PATENT APPLICATION

Appln. No.: 10/020,956

For: TAPE REEL

DECLARATION UNDER 37 C.F.R. § 1.132

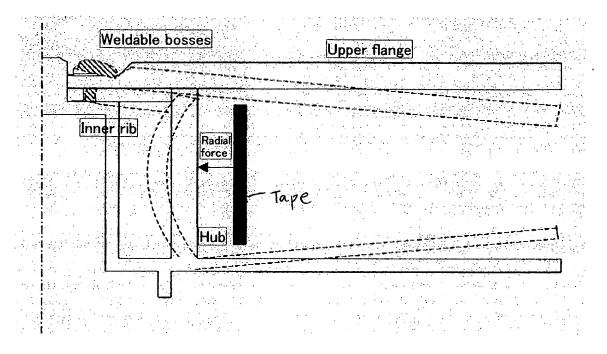
I. More specifically, the Examiner maintains that he

cannot see the upper and lower flanges moving towards each other when the magnetic tape is being wrapped around the hub. For instance, in Figure 2, the outer wall 11a is connected to the lower flange 13, but the upper flange 12 is not connected to the outer wall 11a, instead it is fastened by 11e. Therefore, as the magnetic tape is being wound around the hub, only the lower flange 13 would move toward upper flange 12 because of the force on the hub is buckling the lower flange, thus decreasing the distance between said upper flange and said lower flange. The upper flange 12 cannot be moved even though it is secured to the hub by fasteners.

Further, in the Advisory Action dated January 5, 2004, the Examiner alleges that pages 7 and 8 of the subject application explain that the upper flange 12 is bonded to hub 11, "only by means of the weldable bosses 11e, and nowhere in the specification points out that the upper flange 12 is bonded to the outer peripheral wall 11a." (emphasis in the original).

In particular, I explain the principle of the moving of the upper flange and the lower flange.

- 1) The upper flange 12 and the hub wall 11a are not welded, as is shown in the following figure.
- 2) The hub 11 is deformed as shown in the figure by the radial force of the tape. The upper flange is connected with the hub via the weldable bosses 11e. A

cylindrical portion of the hub is deformed in a radial direction, as shown in broken lines by winding the tape, thereby an inner rib is also deformed. The deformation of the inner rib causes a inclination of the base portion of the weldable bosses and the upper flange is deformed as shown in the figure.
